On November 13, 1978, the Commission issued Amendments Nos. 37 and 5 to Facility Operating Licenses Nos. DPR-51 and NPF-6 for Arkansas Nuclear One, Units Nos. 1 and 2 (ANO-1 & 2), respectively.

- Page 5-9 (Figure No. 5-1)
for ANO-1, License No. DPR-51
- Page 5-10 (Figure No. 5-1)
for ANO-2, License No. NPF-6

ARKANSAS POWER & LIGHT CO.
ARKANSAS NUCLEAR ONE

ENVIRONMENTAL SURVEILLANCE
ORGANIZATION CHART

FIG. NO.
5-1

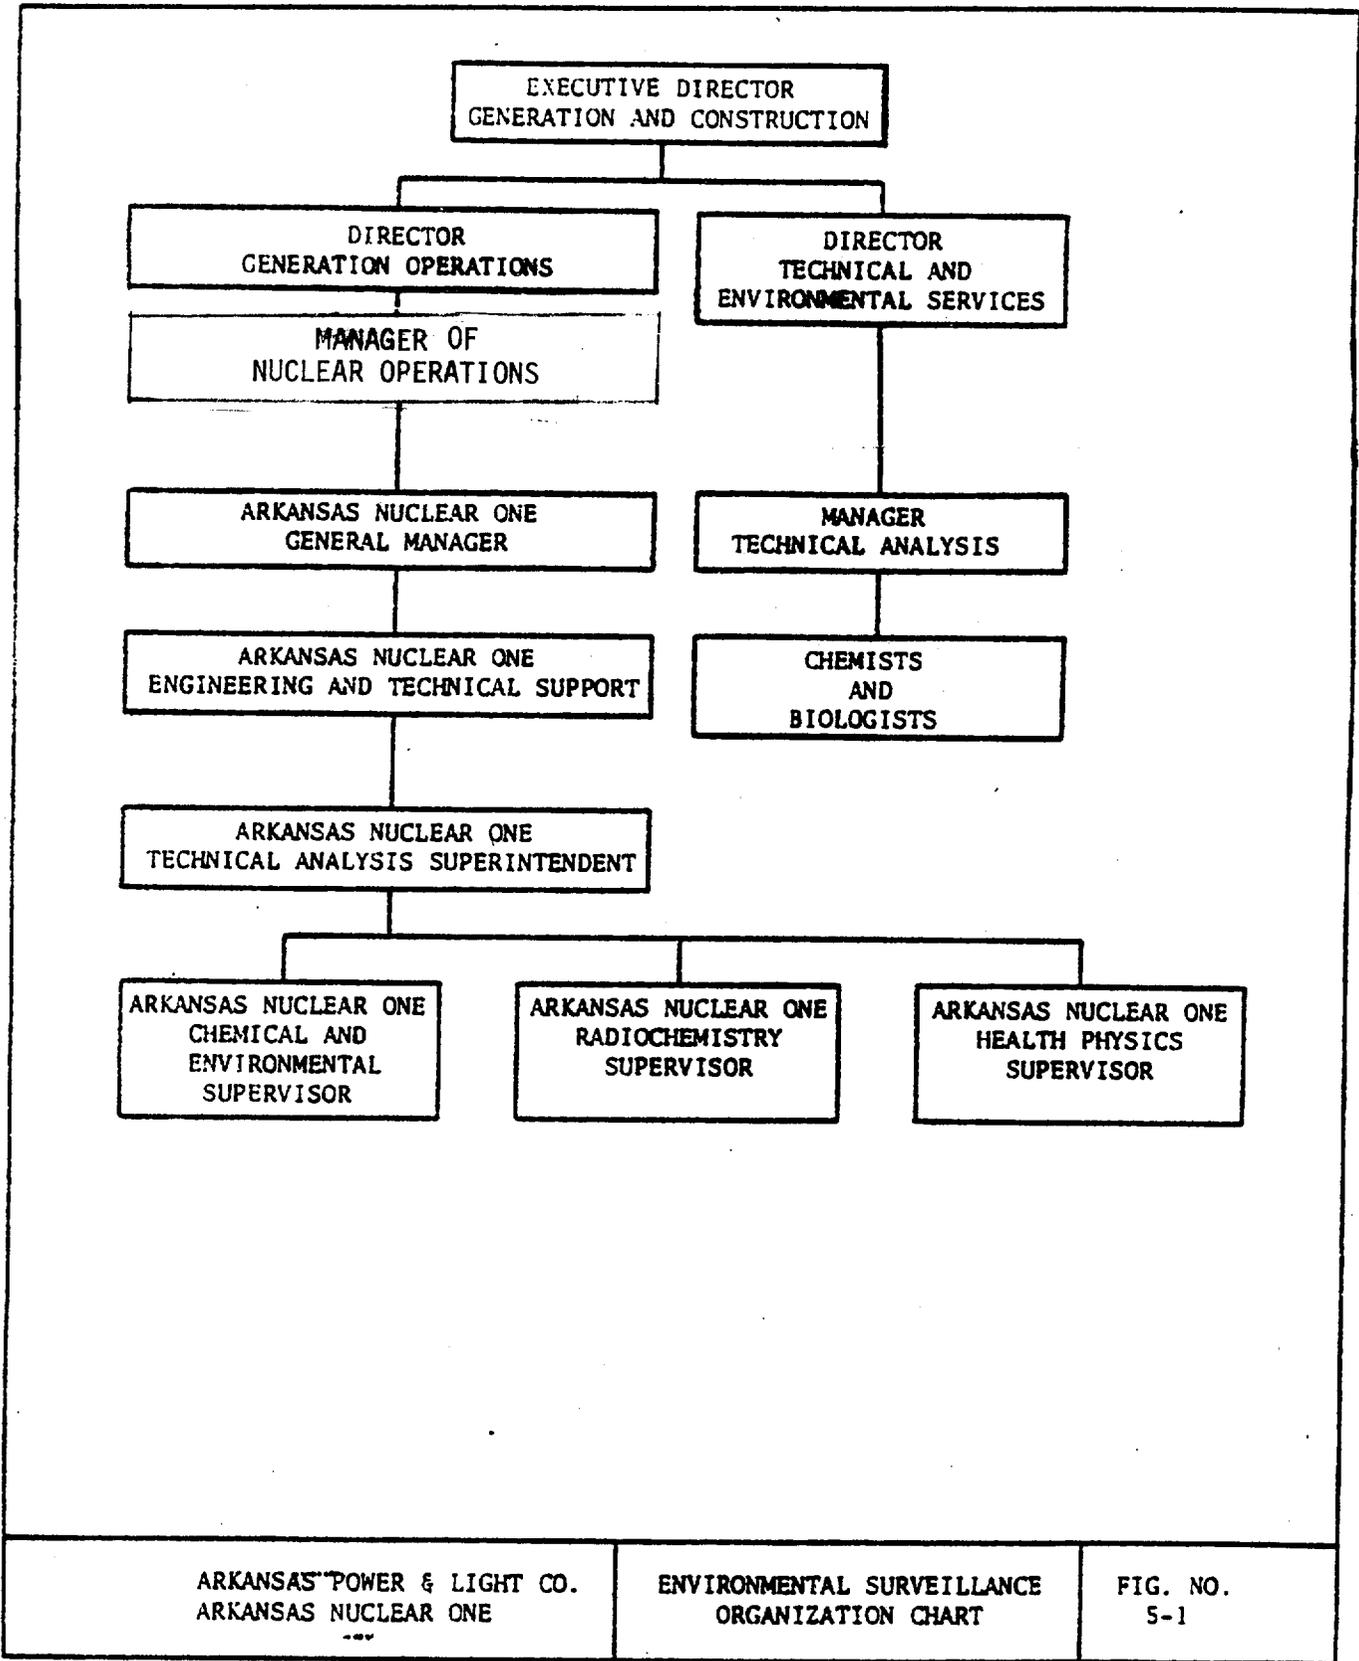
These amendments modified the Technical Specifications dealing with the plant organization structure and revised the ANO-1 Administrative Controls of the Environmental Technical Specifications to make them current and consistent with ANO-2. However, the position of "Manager of Nuclear Operations" was inadvertently omitted from Figure No. 5-1, "Environmental Surveillance Organization Chart," of the Environmental Technical Specifications for ANO-1 & 2.

We have corrected this error and have enclosed revised pages for insertion in your Technical Specifications.
